PLANNING AND DEVELOPMENT SERVICES STAFF REPORT

For Planning Commission Meeting of September 8, 2011

**SUBJECT: University Bank PUD Supplemental Regulations and PUD Site Plan
(2015 Washtenaw Avenue)
File Nos. Z09-028 & SP09-029**

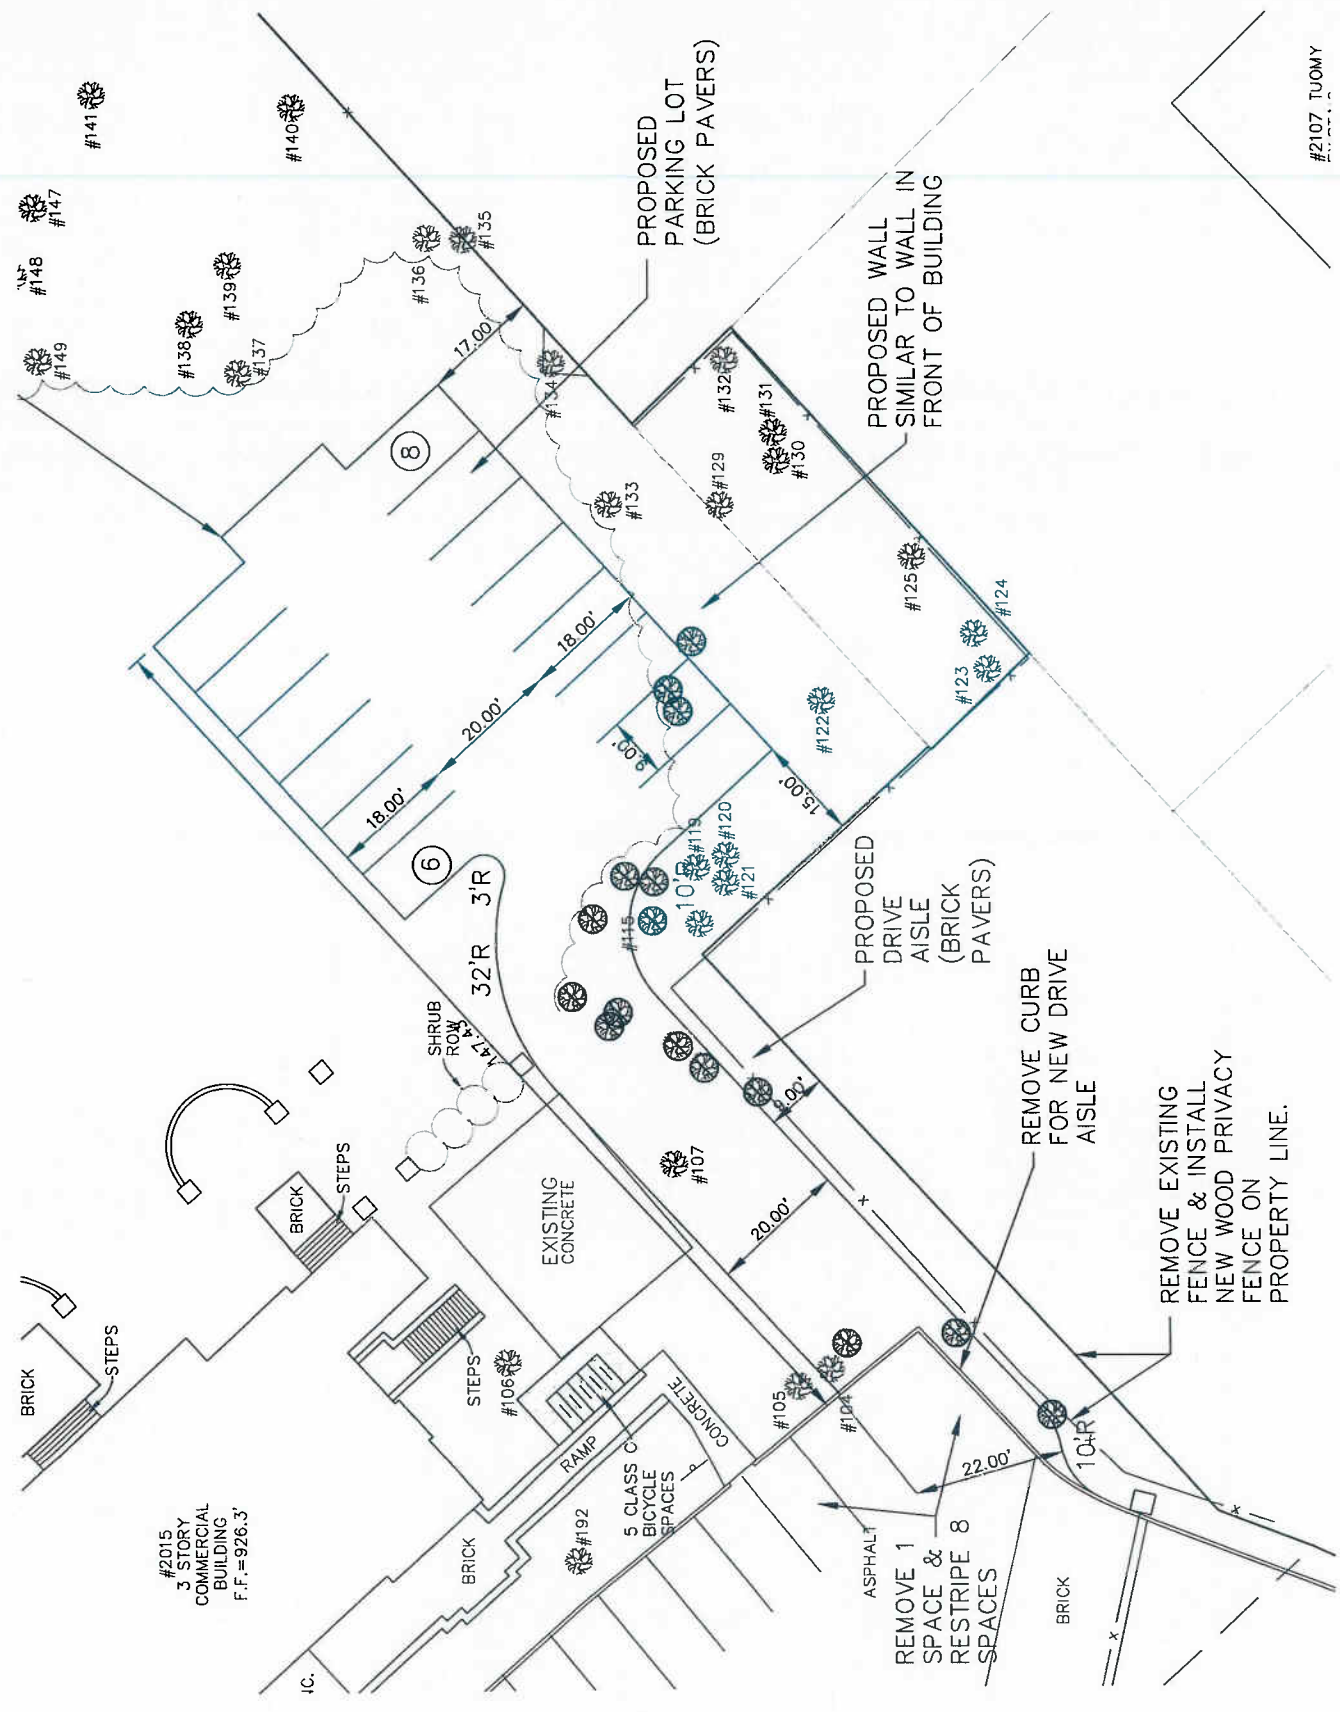
As you are aware University Bank has petitioned the city of Ann Arbor to modify our PUD to allow the construction of a 14 space parking lot on our site at 2015 and also increase the maximum number of employees allowed from 50 to 60. This additional parking would result in a net increase of 13 spaces bring the total number of spaces on the site to 47. After extensive discussion with City of Ann Arbor planning staff we have developed two alternative plans for you review. Please review the enclosed sketches. Alternative #1 moves the lot further from the property line and also avoids more trees than the original plan. Alternate #2 moves the parking to the front of the building and would avoid more trees as well as allow for the addition of up to 15 spaces.

Please let me know your thoughts on the enclosed sketches. If you have any suggestions, concerns or comments please forward them to me. I would be happy to meet with anyone that would like to discuss this project.

SHEET NO. C-4

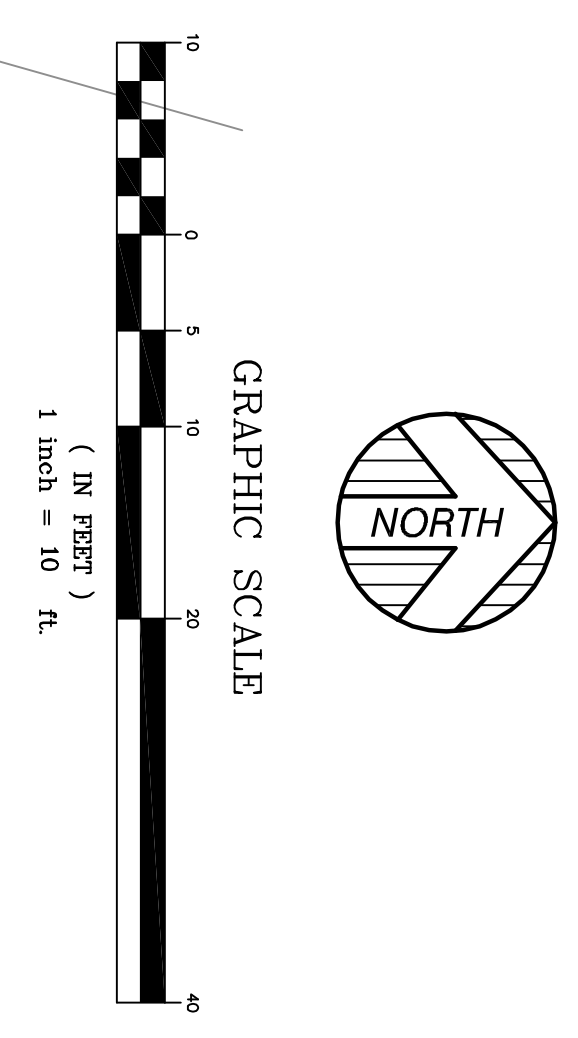
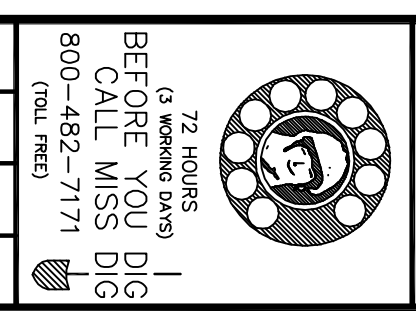
REVISION	DATE	BY	DESCRIPTION
02	08/11/10	MDK	REVISED PER CITY COMMENTS
01	05/13/10	MDK	REVISED PER CITY ADC MEETING & COMMENTS
